CBD AND SOUTH EAST LIGHT RAIL (CSELR)
EIS NOISE & VIBRATION ASSESSEMENT
INDEPENDENT ADEQUACY REVIEW & GAP ANALYSIS

REPORT NO. 14055
VERSION A

APRIL 2014

DEPARTMENT OF PLANNING
& INFRASTRUCTURE (DP&I)
BRIDGE STREET
SYDNEY NSW 2000

Figure 3-1 Residential Exceedance Locations

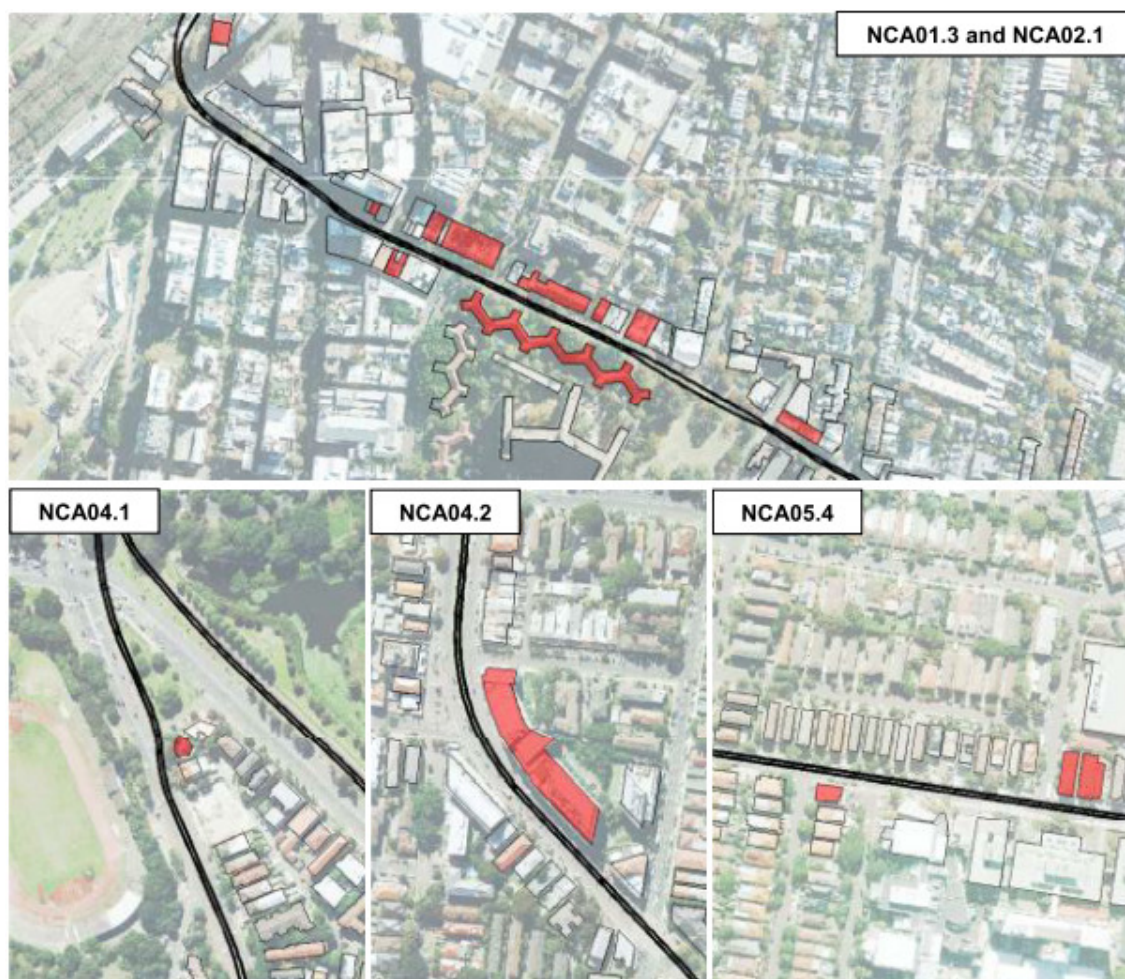
As shown in Table 3-2, the greatest potential impacts appear to be within the Surry Hills Precinct. In this area, the daytime $L_{Aeq,15hr}$ trigger level is predicted to be exceeded by up to 2 dB and the night time $L_{Aeq,9hr}$ trigger level is predicted to be exceeded by up to 5 dB. Additionally the L_{Amax} trigger level is predicted to be exceeded by up to 3 dB.

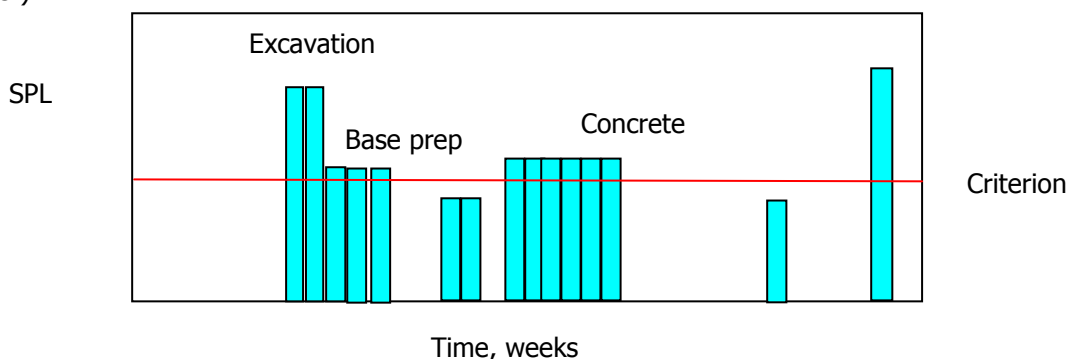
Query/ Recommendation: Please review Table 36 in the Report which presents predicted noise levels from the Rozelle Maintenance Facility. Given the location of the noise sources, it is surprising that the highest noise levels are on the ground floor. It is unclear where the receiver locations are. The assessment needs to present noise contour or façade plots or a plan showing receiver locations to indicate where the noise impacts are for each noise scenario.

Figure 1 FTA Guideline Allowable Increase in Cumulative Noise Levels

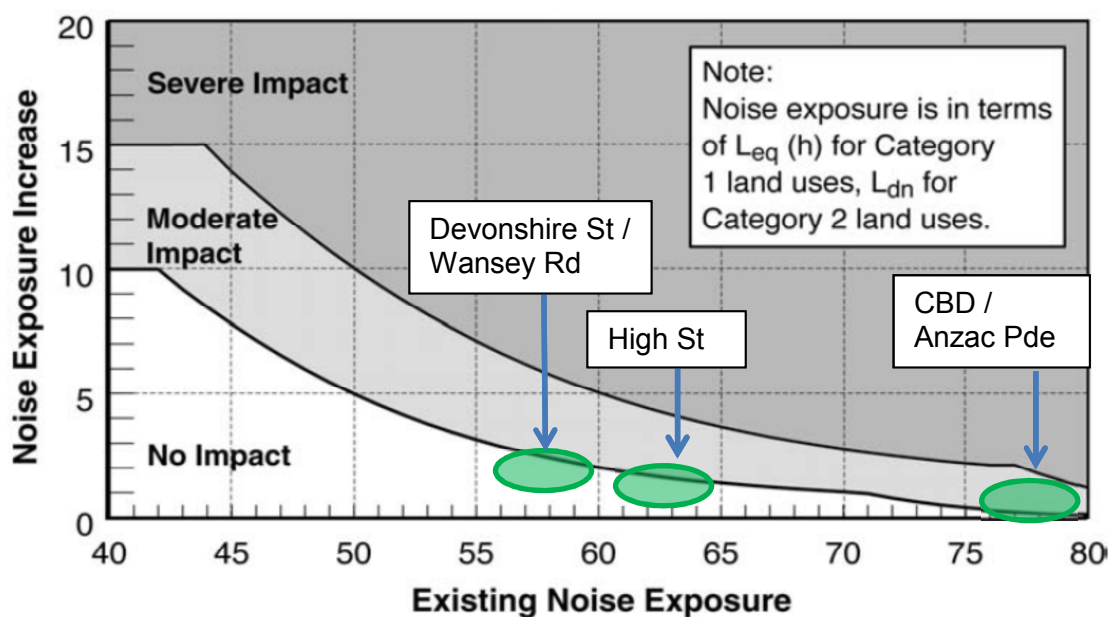
Figure 1 has been reproduced from the FTA Guideline, with the indicative impacts at key locations along the CSELR alignment. It indicates that in existing quiet areas such as Devonshire Street or Wansey Road, an increase in overall ambient noise levels of 2 dB to 3 dB would be acceptable. A 2 dB increase would also be acceptable in High Street, Randwick. In existing high-noise areas, the acceptable increase due to a transit project is almost zero. However, it is noted that in these areas the light rail noise would not be expected to contribute significantly to the overall LAeq(9hour) noise levels.

Figure 3 Randwick Stabling Model and Receivers

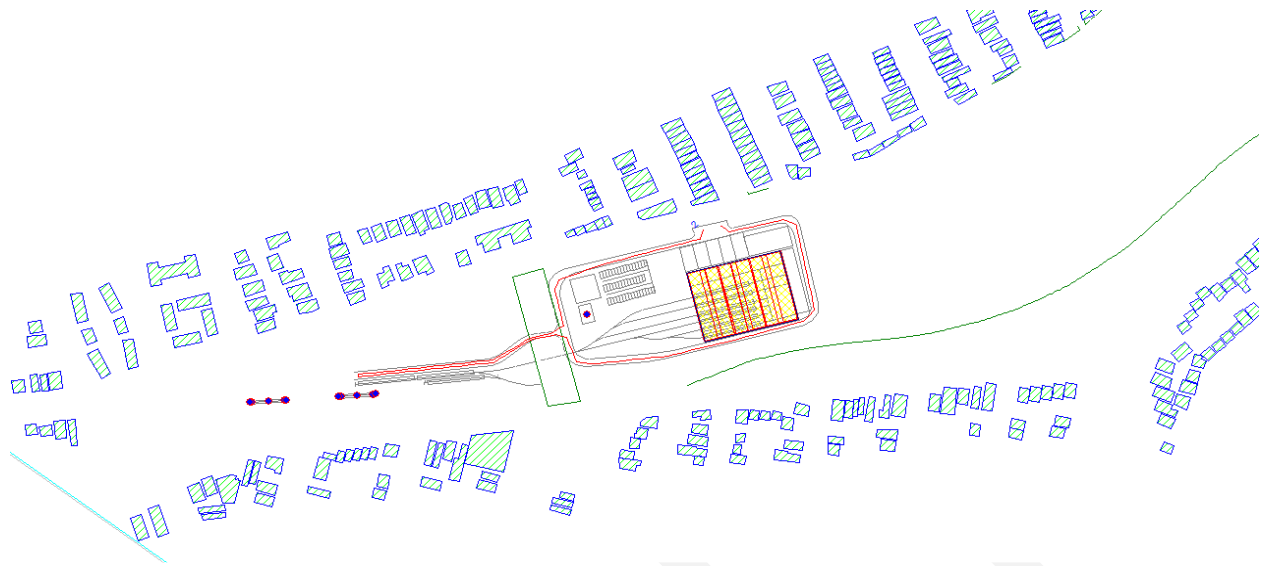
Query/ Recommendation: The report confirms that noise is a significant concern with this site and raised the issue of barriers / partial roofs or a complete shed, without including any plans or elevations showing the extent of these building areas. With the extent of the impacts and non-compliance of the night time noise criteria presented in the report it is recommended that the noise assessment be revised in detail to show how noise will be mitigated/managed and achieve INP criteria. The assessment needs to address the issues highlighted above, present plans, cross sections and elevations showing the extent of mitigation, show noise contour or façade plots to indicate where the noise impacts are for each scenario, exact source locations for each scenario, etc.

The receivers and source locations considered in the assessment are shown in **Figure 3**.

Figure 5 Indicative Construction Impacts on Residential Receivers – City Centre

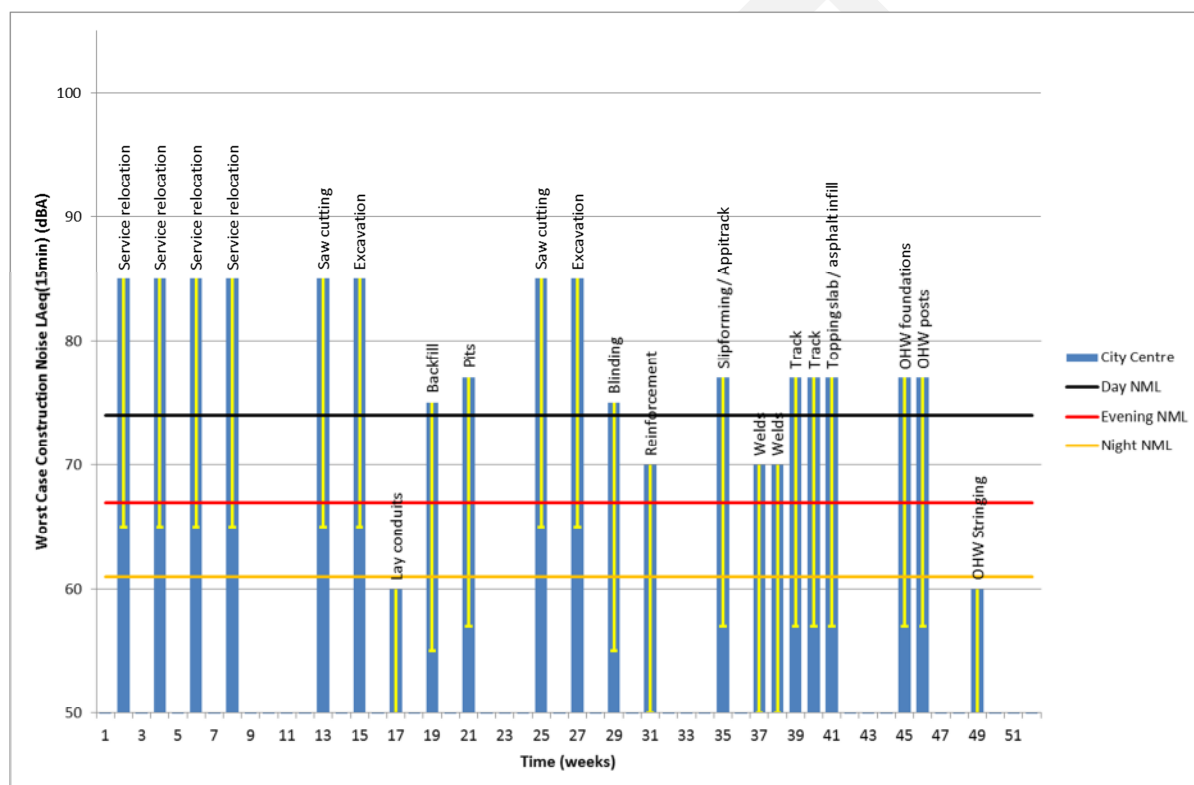
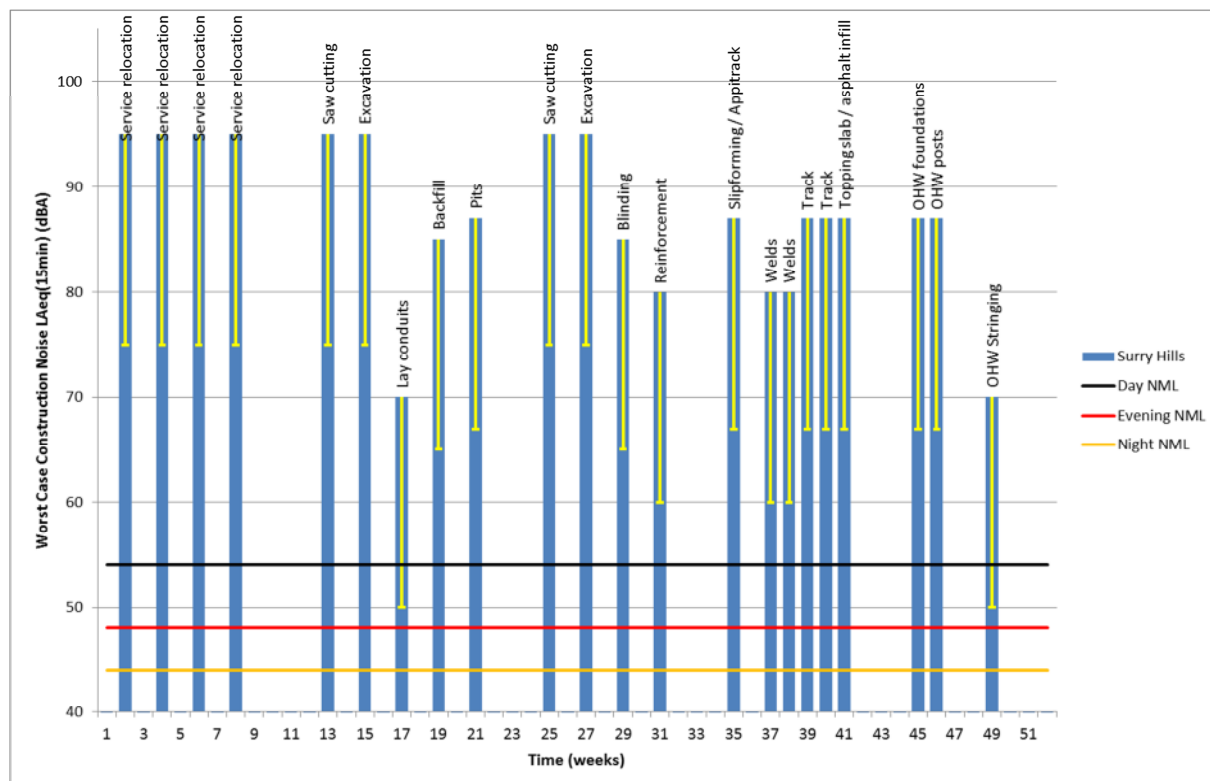
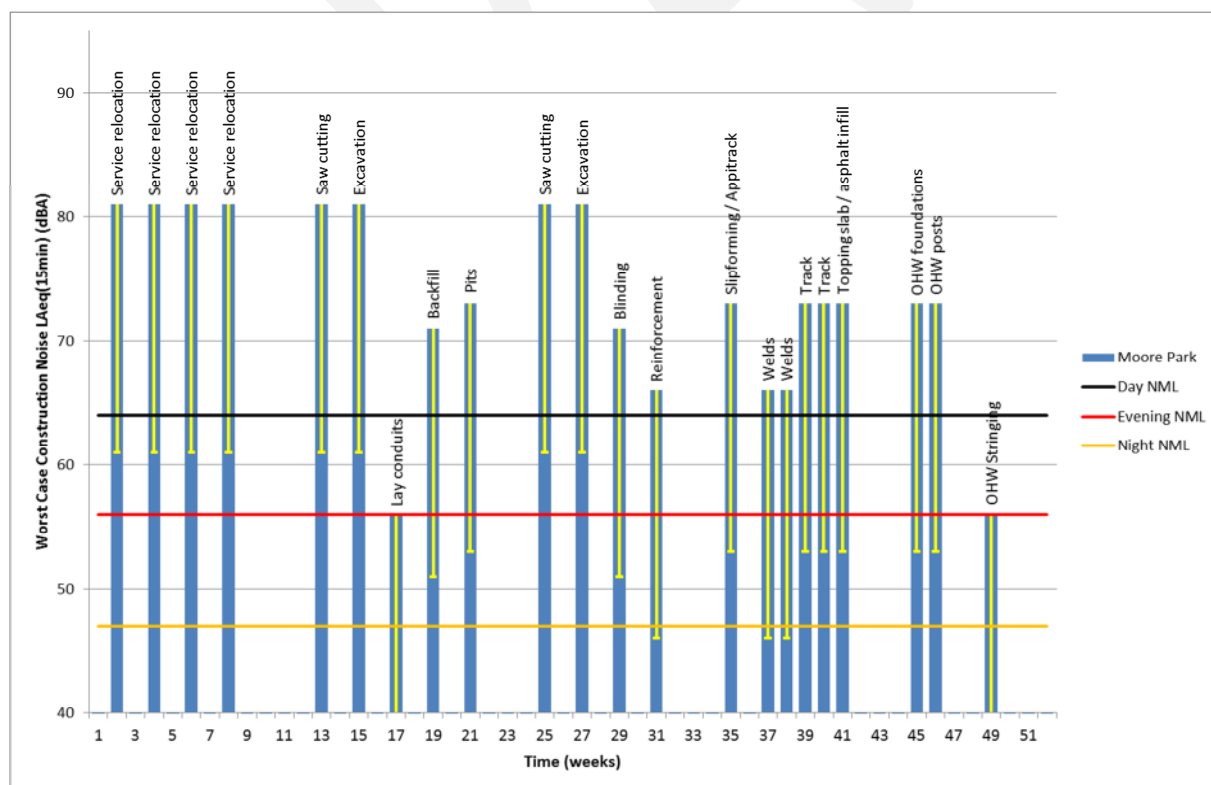
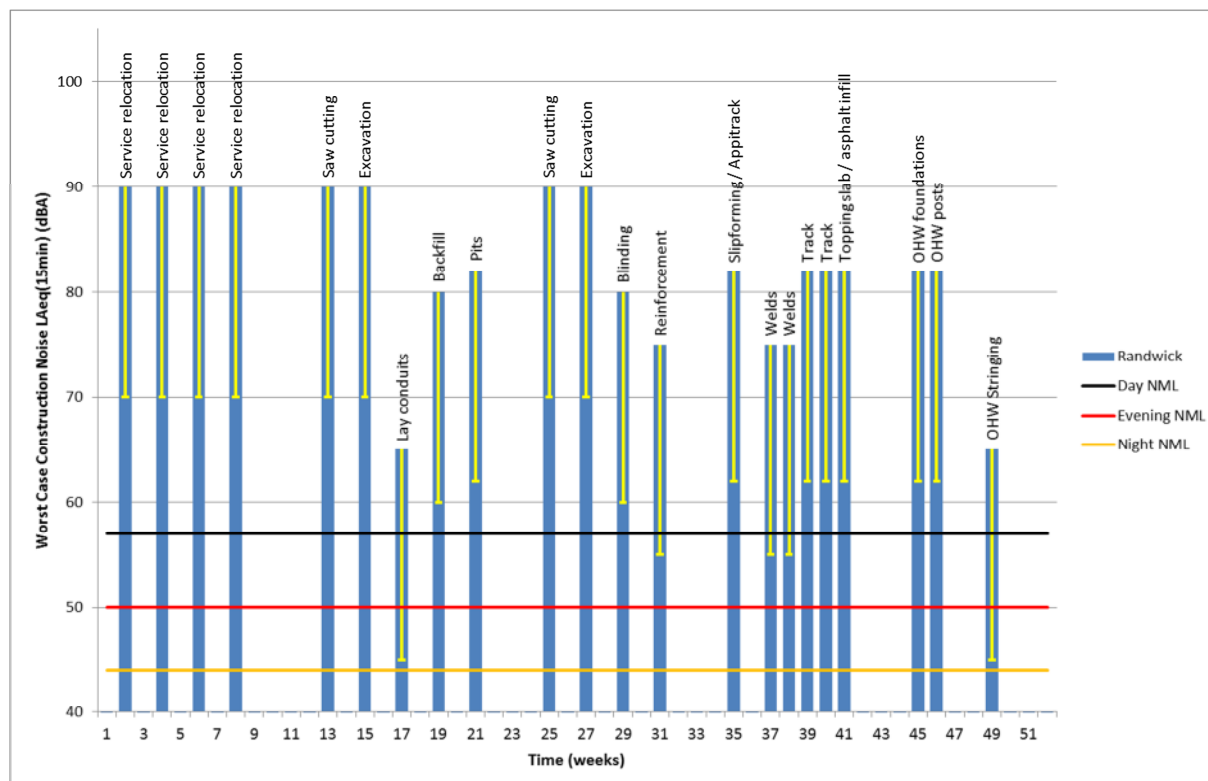
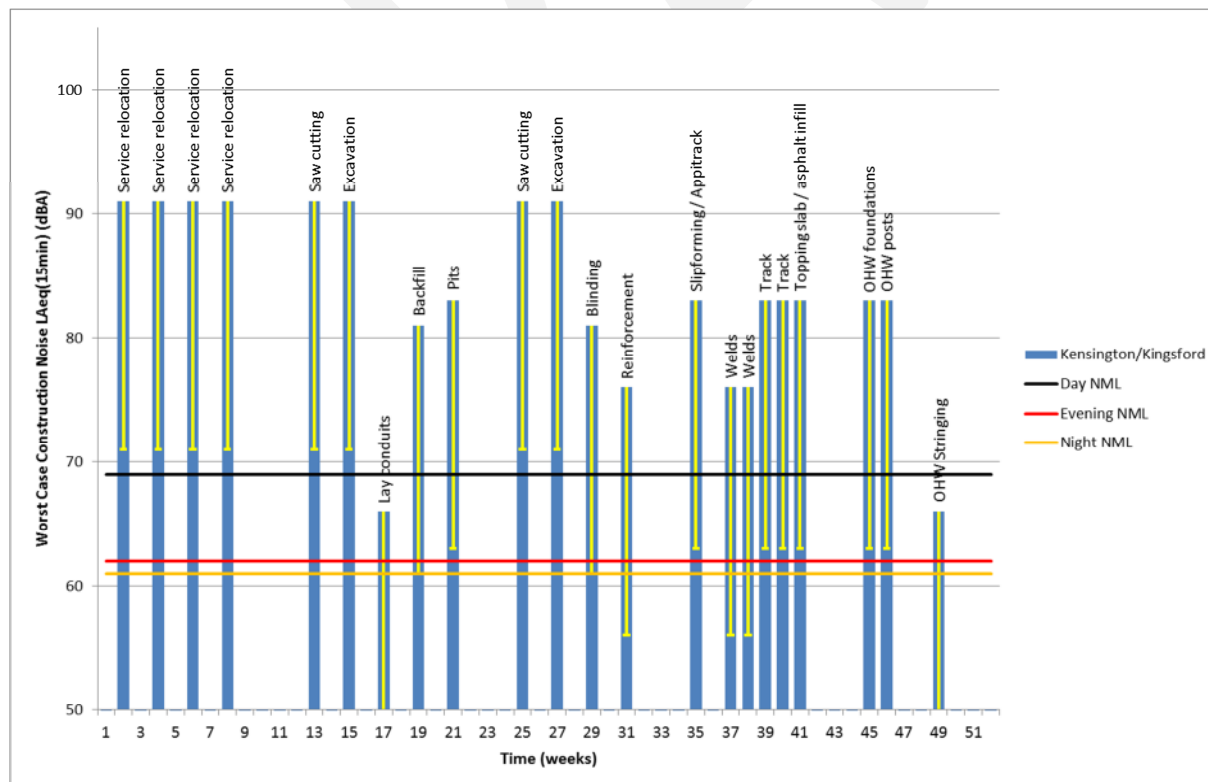
Query/ Recommendation: It is unclear the level and duration of the noise impact at locations along the construction of the light rail system. To understand the construction noise impacts along the construction of the track it is requested that a noise profile be constructed for a typical (worst) receiver (day, evening and night) and show in graphical terms the duration of construction in each of the areas, namely:

Indicative construction noise profiles for each precinct have been provided (Appendix B, Figures 5-9). It is recommended that these form the basis of further construction noise assessment during detailed design and are revised and included in construction noise management plans, subject to the project being approved.
